UNITED STATES
NUCLEAR REGULATORY COMMISSION
WASHINGTON, D.C. 20555-0001

October 23, 2017

SUBJECT: DIABLO CANYON POWER PLANT, UNIT NOS. 1 AND 2 – NUCLEAR
REGULATORY COMMISSION RESPONSE TO REQUEST FOR EXTENSION
OF SEISMIC PROBABILISTIC RISK ASSESSMENT SUBMITTAL SCHEDULE

Figure 5.0-2: Comparison of GMRS and LTSP Seismic Margin Spectrum for DCPD (5% Damping)

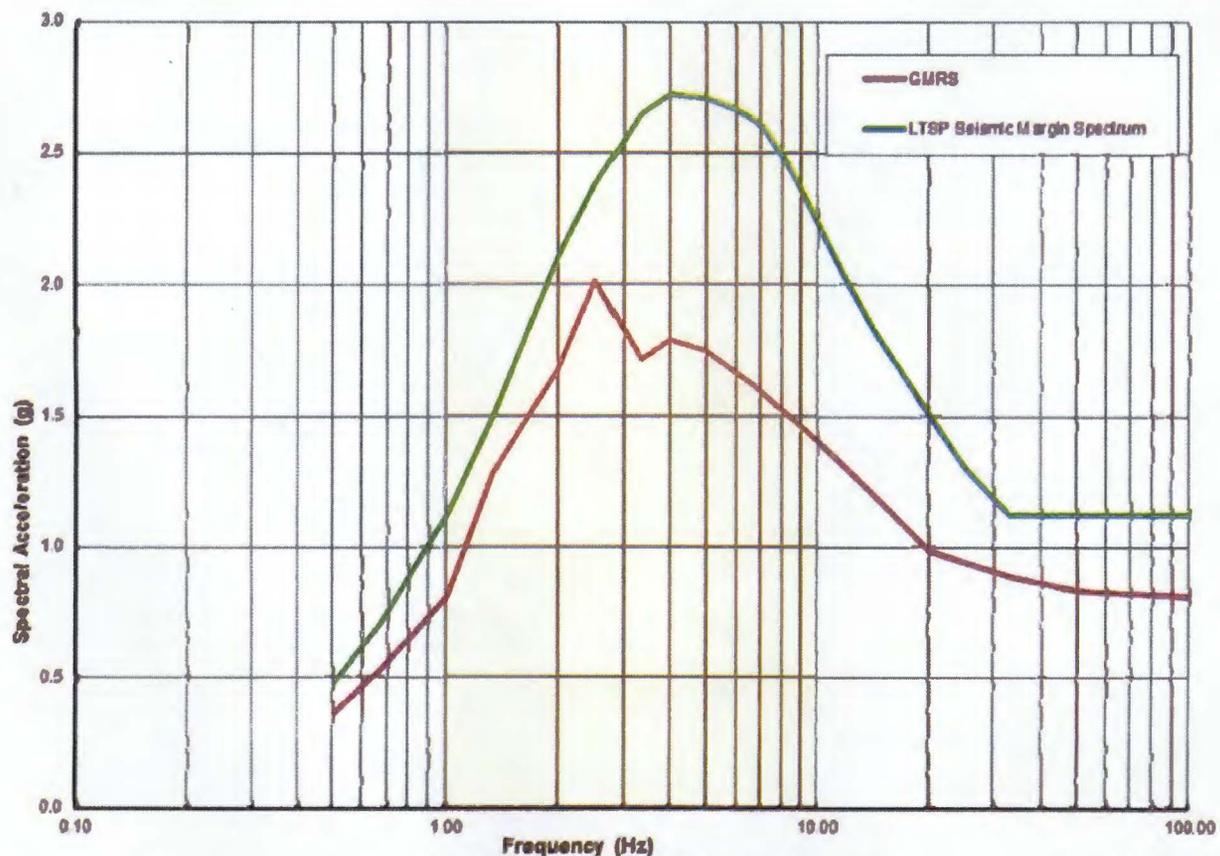
The ability of DCPD to cope with earthquakes larger than the design-basis earthquake while the longer-term evaluation is performed is documented in the licensee's reevaluated hazard submittal dated March 11, 2015, "Response to NRC Request for Information Pursuant to 10 CFR 50.54(f) Re. the Seismic Aspects of Recommendation 2.1 of the Near-Term Task Force Review of Insights from the Fukushima Dai-ichi Accident: Seismic Hazard and Screening Report" (ADAMS Accession No. ML15071A046). In its submittal, the licensee stated that all structures, systems, and components required for safe shutdown have been evaluated to the 1988 Long-Term Seismic Program (LTSP) spectrum and found to have significant seismic margins. The LTSP Seismic Margin Spectrum was compared to the reevaluated seismic hazard or ground motion response spectrum (GMRS). In its submittal, the licensee provided Figure 5.0-2 (reproduced below), "Comparison of GMRS and LTSP Seismic Margin Spectrum for DCPD (5 percent Damping)."

The comparison clearly shows that the GMRS is bounded by the LTSP Seismic Margin Spectrum at all frequencies with sufficient margin. Therefore, the staff has high confidence that, in the unlikely event of an earthquake up to the magnitude of the reevaluated seismic hazard during the extension period, safe shutdown equipment will perform its function, and there is not undue risk to the public while the longer-term evaluation is being performed.
